Contract #: 04-0120F4Cty: SF/ALA Rte: 80 PM: 13.2/13.9File #: 69.25B**QUALITY ASSURANCE -- NON-CONFORMANCE REPORT****Location:** Changxing Island, Shanghai, P.R. China**Report No:** NCR-000502**Prime Contractor:** American Bridge/Fluor Enterprises, a JV**Date:** 27-Oct-2009**Submitting Contractor:** Zhenhua Port Machinery Company, Ltd (ZPMC), Changxing Island**NCR #:** ZPMC-0475**Type of problem:**

Reference Description: ZPMC moved segment 6AW to the Blast Shop prior to completion and obtaining the "QA Approval Form" per CCO77

Job Name: SAS Superstructure

Subject: NCR No. ZPMC-0475

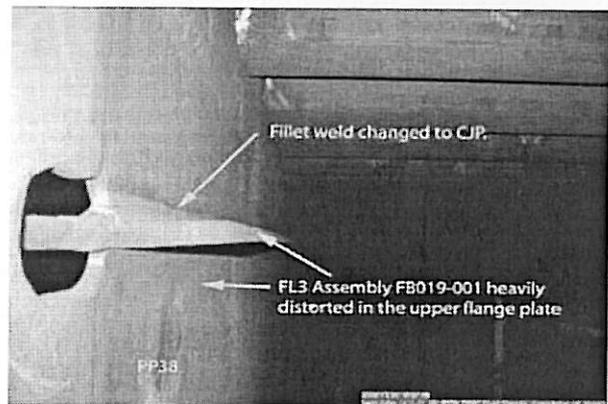
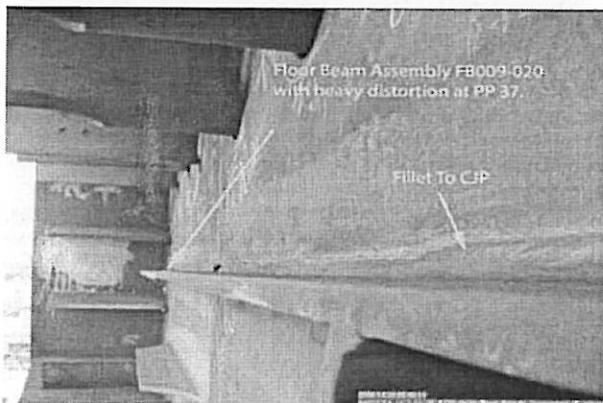
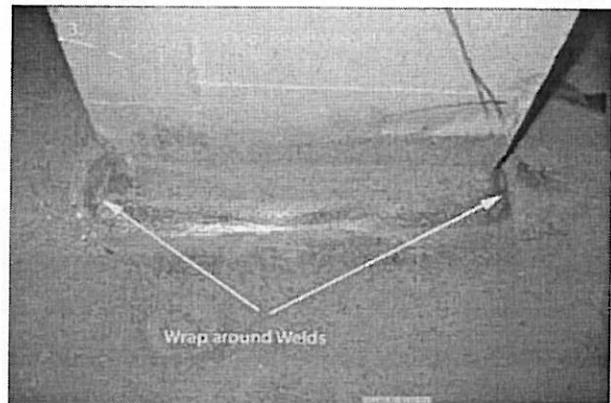
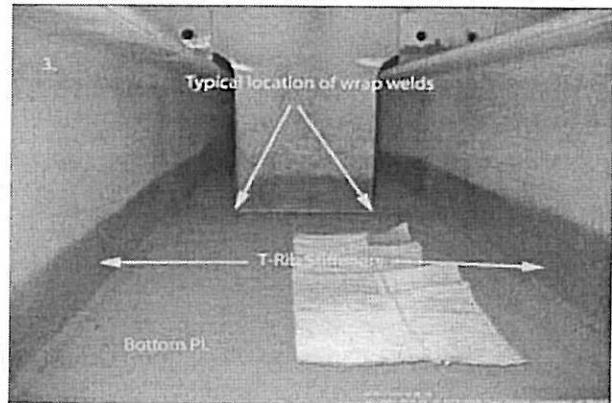
1. The transverse X37 Deck Brackets in this segment require a fillet weld per approved drawings with the maximum root opening not to exceed 5mm as allowed by AWS D1.5-2002 Section 3.3.1. The termination of these fillet welds at the following locations show a root gap greater than that allowed by the code:

X37 Brackets at Location W2 at panel points 37.25, 37.75, 38.25, 38.75, 39.25, 39.75, 40.25, and 40.75.

X37 Brackets at Location W5 at panel points 37.25, 37.75, 38.25, and 38.75.

Address distortion issues by heat straightening, remove X37 brackets and butter ends to correct excessive root opening.

Contractor has performed heat straightening at said location, and flange is now in conformance with Contract specifications. X37 brackets were removed and excessive root openings were repaired via buttering.

项目名称 Project Name	美国海湾大桥 SFOBB	部件图号 Drawing No	X37	报告编号 Report No.	B-WR5177
合同号 Contract No.:	04-0120F4	部件名称 Items Name	角单元筋板 Corner assembly stiffener	NDT报告编号 Report No.of NDT	NA
项目编号 Project No.:	ZP06-787

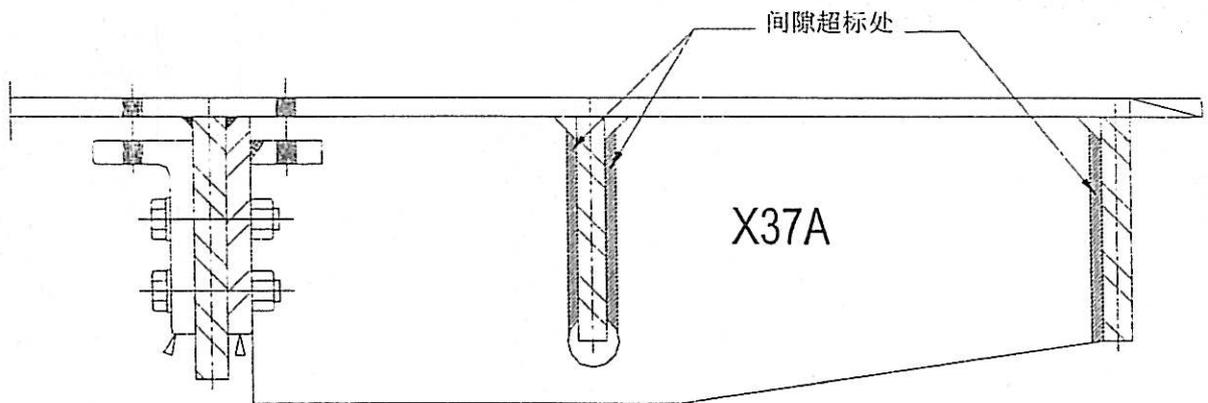
经检查发现箱梁6AW角单元内件X37A与顶板I肋装配间隙超标, 最大为6.4mm (工艺要求最大间隙不超过5mm), 涉及焊缝为: CA025-025~030\037~042\049~054\061~066\073~078\085~090\101~106\113~118, SEG027J-139\140\143~146\127~132\007\008\011~014.

After inspection box 6AW assembly inner X37A and deck plate I-rib, the gap was maximum 6.4mm, which shall be 5mm, weld ID: CA025-025~030\037~042\049~054\061~066\073~078\085~090\101~106\113~118, SEG027J-139\140\143~146\127~132\007\008\011~014.

1. 按照图纸要求对件X37A进行堆焊处理;
2. 将要修补的区域打磨光滑;
3. 准备一个正确的接头形式, 具体参见返修的WPS;
4. 做100%VT和100%MT, 并按照图一所示加钢衬垫, 具体参见AWS D1.5.3.13;
5. 根据返修的焊接返修工艺规程(WPS)进行预热及焊接;
6. 焊后去除钢衬垫, 将焊缝打磨至与母材平齐;
7. 根据图纸要求进行相应的NDT(VT、MT和UT)检测;

1. Perform surfacing to item X37A per work drawing;
2. Grind the edge of the repair area cleanly;
3. Prepare an right joint according to the approved WPS;
4. Perform 100%VT and 100%MT, and add steel backing according to the attached drawing 1 and AWS D1.5.3.13;
5. Preheat and weld according to the relevant WPS;
6. Gouge off the steel backing and grind the weld flush with base metal after welding;
7. Perform NDT inspection(VT、MT and UT) of the weld according to the working drawings.

HSR1(B)-7886

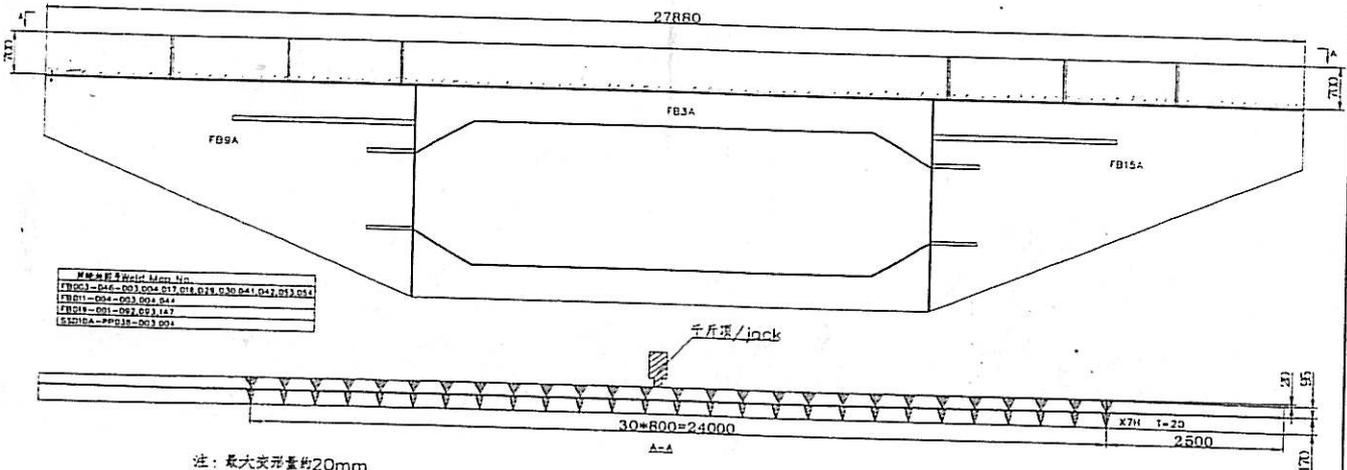
Cause原因 Welding distortion 焊接变形
 Type of Defect缺陷类型 Welding distortion 焊接变形
 Inspection Method检查方法 Visual 目检

注: 最大变形量约20mm
 NOTE: the max deformation is about 20mm

缺陷去除方法(Defect Removal Method): natural gas 天然气

后续NDE(Post-Removal NDE): After finishing heat straightening, the weld of the heat area shall perform NDT according to the approved shop drawing 校火后, 根据图纸要求对热影响区域进行NDT检测。

纠正措施(Corrective Action(s)): Control current, voltage and weld speed according to relevant WPS. If necessary anti-deformation or hold down device can be added. 依据相应的WPS的要求控制电流, 电压和焊接速度。如有必要, 可使用反变形设施进行校正。

The report of steel plate heat straightening process checking

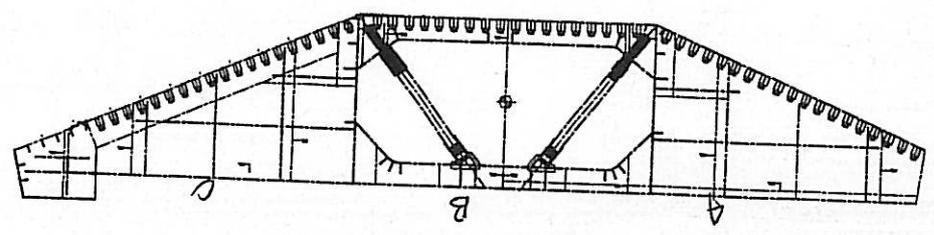
测量点 Measure position:	A	B	C						
测量值 Measure result:	14	20	10

测量点 Measure position:	A	B	C						
测量值 Measure result:	1	2	1

整体平整度/筋板垂直度是否合格
Heat straightening result: A/C
